WORK CHANGE DIRECTIVE NO.: 1

Owner: Town of Erie
 Engineer: HDR Engineer, Inc.
 Contractor: Geo-Solutions, Inc.
 Project: Erie Lake Dam Seepage Rehabilitation
 Contract Name: N/A

Owner's Project No.: P22-91
 Engineer's Project No.: 10405834
 Contractor's Project No.: N/A

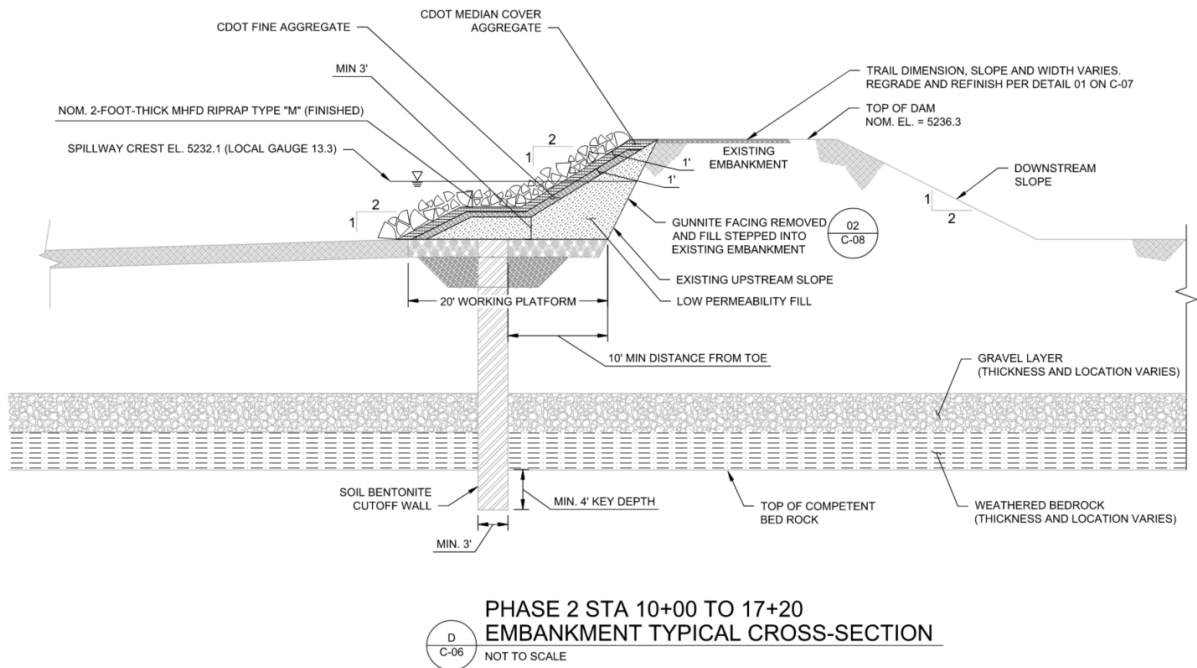
Contractor to provide cost and construct riprap bedding as shown on Cross-Section D on Sheet C-08 of construction drawings sealed March 25, 2026 and identified in 31 23 00, 2.1.B. and C. (screen captures below). This requires a contract amendment due to Bid Items 8 and 9 changing. Geotextile (Bid Item 8) is no longer included in design so new quantity is 0 cubic yards. Bid Item 9 is now two layers of aggregate that are each 1-foot thick instead of previous riprap bedding being 6-inches thick. Engineer's estimate of quantity is 1,285 cubic yards of each aggregate for a total of 2,570 cubic yards but contractor to perform own estimate. Payment still to be on installed cubic yard basis as described in 01 22 00, 1.5.J.

Riprap bedding has changed since Issued for Review/Bid drawings sent to contractor in December during procurement phase of project.
